23/00573/FUL - Highways Comments (Internal Layout)

The following provides a response to LCC Highways' comments in relation to the internal layout, as received on 11th April 2024. It shows the initial comments in black, and Bloor Homes' response in red.

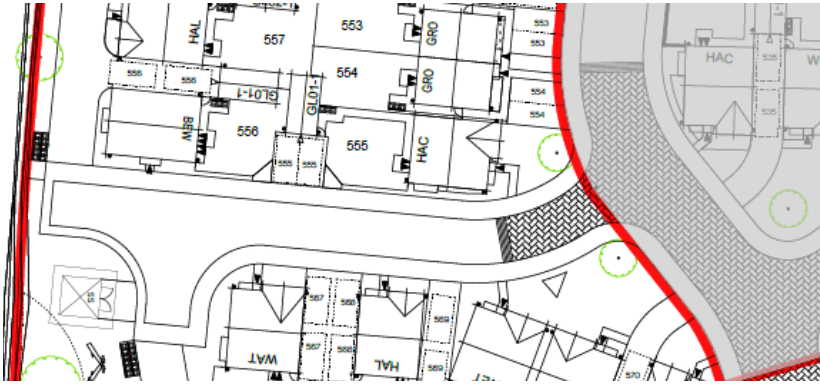
Roads not suitable for adoption

For a road to be considered for adoption it must provide direct frontage access to five properties or more as detailed in the Leicestershire Highway Design Guide (LHDG - available at: <https://resources.leicestershire.gov.uk/lhdg>). Please refer to part 3 points 3.40

The roads detailed below fail to comply with this requirement, please amend the planning layout to resolve this issue.

Road 101 serves one direct frontage and Road 107 serves four direct frontages

Road 101 is no longer proposed for adoption and is to be excluded from the S38 submission.

Plots 556 & 557 have been turned to face directly onto Road 107. It now provides direct access to 6 dwellings.

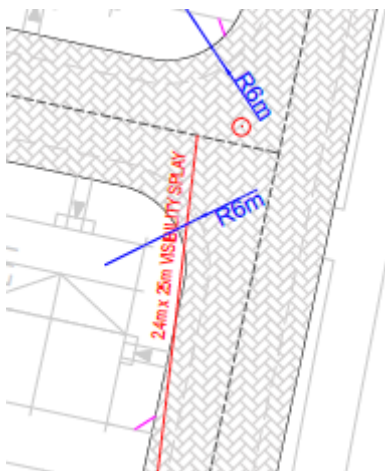
Visibility splay at junction road 102 - the visibility splay detailed below, is shown as being slightly contained within private land please amend the plan to resolve this issue.

The visibility splay now falls within the proposed footpath.
